INSTALLATION INSTRUCTIONS FOR THE 178728 MODIFICATION KIT TO PROVIDE AN IMPROVED CHARACTER COUNTER FOR THE MODEL 28 KEYBOARD (LAK)

a. The 178728 Modification Kit provides an improved character counter for the Model 28 Keyboard (LAK). The kit includes all the necessary parts for field conversion of the LAK Keyboard Character Counter.

FIGURE 1

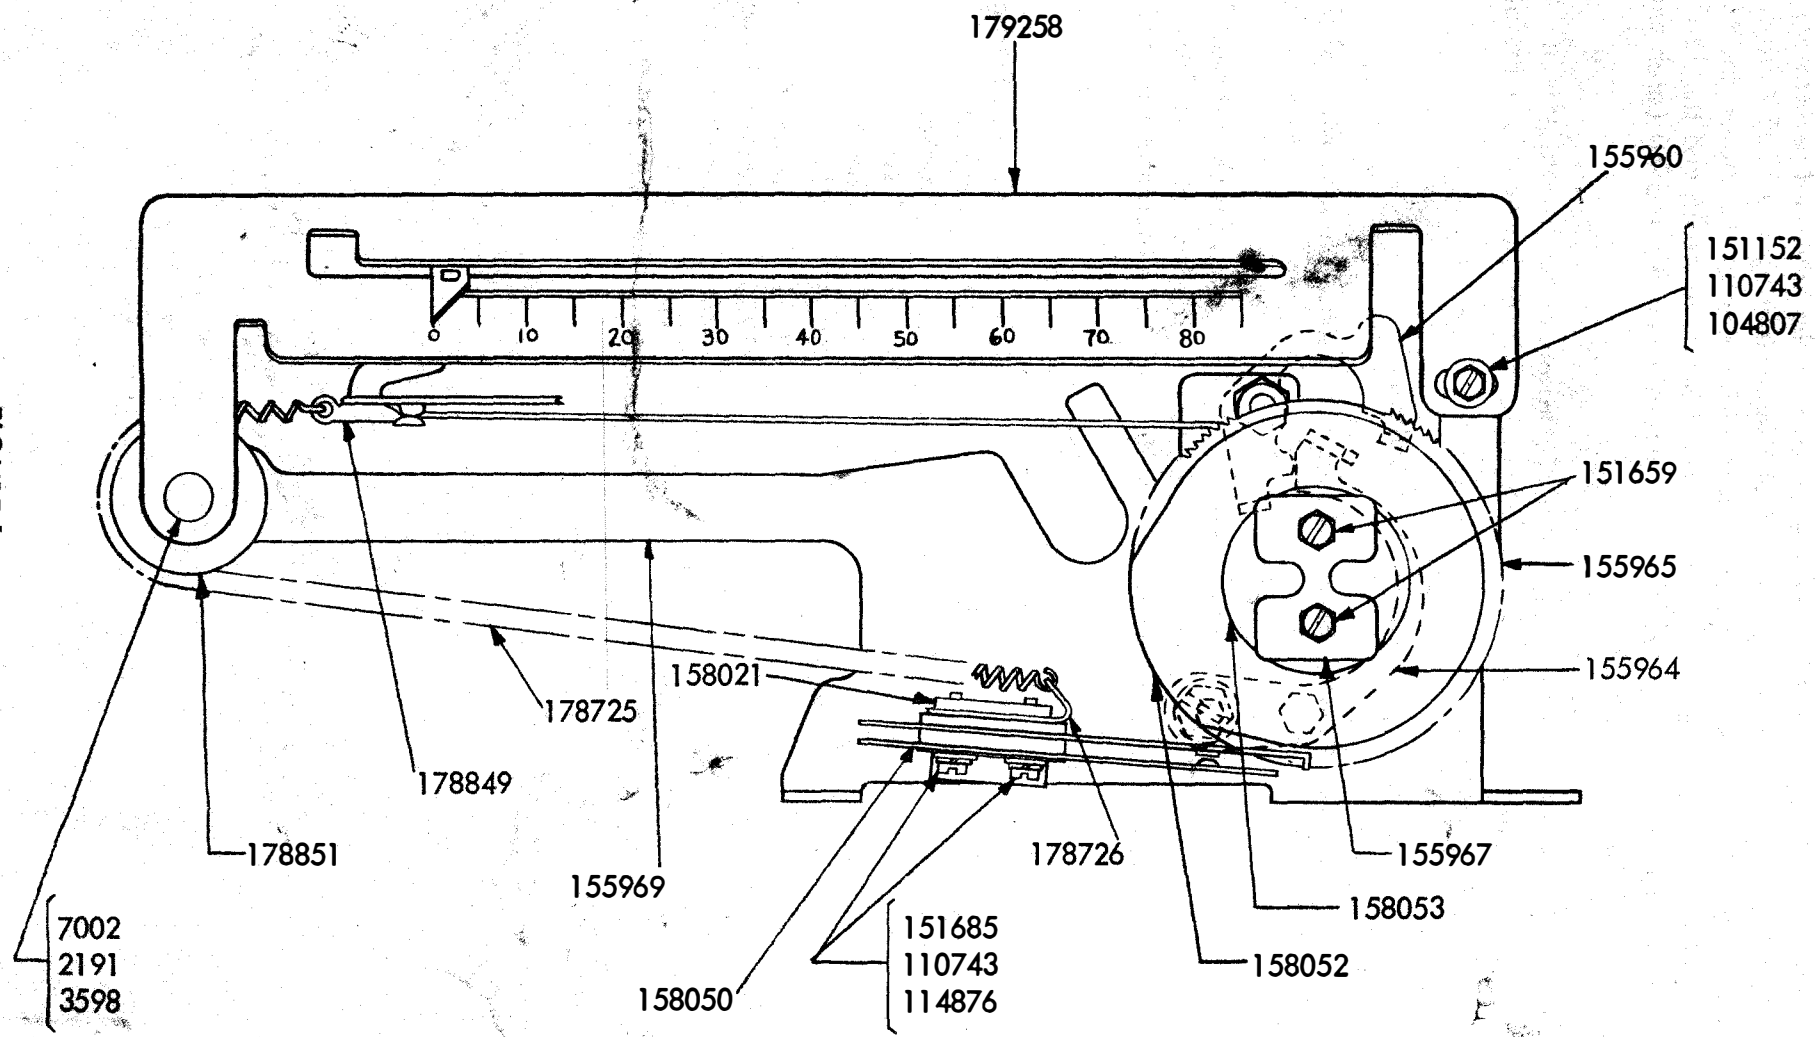
b. Operational failures in the field have resulted from a bind of the nylon pulleys on their bearings due to a taut cord. The taut cord is brought about by the characteristic expansion of the nylon pulleys and the shrinkage of the dacron cord under varying atmospheric conditions. The above problems are eliminated by the 178728 Modification Kit since the cord is no longer wound around both pulleys. The return spring is attached to the left end of the indicator, routed over the idler pulley, and attached to a spring terminal mounted under the contact assembly.

2. INSTALLATION (See Figure 1.)

a. Remove the two 153799 Screws from the 158019 Baffle. Remove and discard the 158019 Baffle, 158047 Scale and 158046 Bracket and all associated mounting hardware.

b. Remove and discard the 158051 Pulley and 158045 Stud by removing the 3598 Nut, 2191 Lock Washer and 7002 Flat Washer. Retain the mounting hardware.

c. Carefully remove the 152839 Spring from the old 155960 Latch. Remove the 3606 Nut and 1118 Shoulder Screw and retain. Discard the old 155960 Latch and replace with the improved latch provided, utilizing the mounting hardware retained above.

d. To remove the old 155964 Stop Lever, remove and retain the following mounting hardware: 119662 Screw, 124177 Lock Washer, 151631 Screw, 2191 Lock Washer, 158147 Eccentric Bushing and 155968 Flat Washer. Discard the old 155964 Stop Lever and replace with the improved stop lever provided, utilizing the retained mounting hardware.

*e. Position the 179258 Scale Bracket W/Stud by placing the 178851 Pulley over the 179258 Bracket Stud with its projection toward the 155969 Bracket. Fasten the 179258 Scale Bracket W/Stud to the 155969 Bracket with a 151152 Screw, 110743 Lock Washer and 104807 Flat Washer, provided, on the right end and with a 7002 Flat Washer, 2191 Lock Washer and 3598 Nut, (retained in Para. 2.b. above) on the left end.

*f. Remove and discard the 158054 Indicator Cord Assembly with terminal, 158056 Reset Cord with terminals, and 159340 Ratchet Return Spring by removing the 151659 Screw, 155967 Spring Washer, 158053 Ratchet Drum Clamp and 158052 Switch Cam.

*g. Insert the indicator of the 178849 Indicator Cord Assembly through the enlarged portion of the slot of the 179258 Scale Bracket W/Stud. With the 155965 Ratchet in its fully counterclockwise (zero) position, insert the terminal end of the 178849 Indicator Cord Assembly in the upper slot of 155966 Ratchet Drum. Re-assemble 158052 Cam, 158053 Clamp, 155967 Washer, and 151659 Screw.

h. To install the 178726 Spring Bracket between the 158021 Switch Bracket and the 158050 Contact Switch, remove two each 151685 Screw, 110743 Lock Washer, and 114876 Flat Washer.

i. Install the 178725 Spring as shown in Figure 1.

1. The 155964 Stop Lever must be adjusted so that a gap of .002 to .010 inch exists between the 158042 Latch Lever and the operating face of the 4th ratchet tooth. The 155960 Latch in its non-operated position must not interfere with the free rotation of the ratchet assembly.

(b) Character Counter Scale - Add the following to this adjustment: The "point" of the indicator should not touch the scale throughout its entire travel. Carefully form the indicator for some clearance.

(d) Character Counter Stroke - Requirement should read: Min. 0.006 Inch
Max. 0.015 Inch

(e) Ratchet Drum Assembly Return Spring - Requirement should read 1/2 to 1-1/2 ozs. when indicator is in the 35 position to start the indicator moving.
1-1/2 to 2-1/2 ozs. when indicator points to 70 to start the indicator moving.
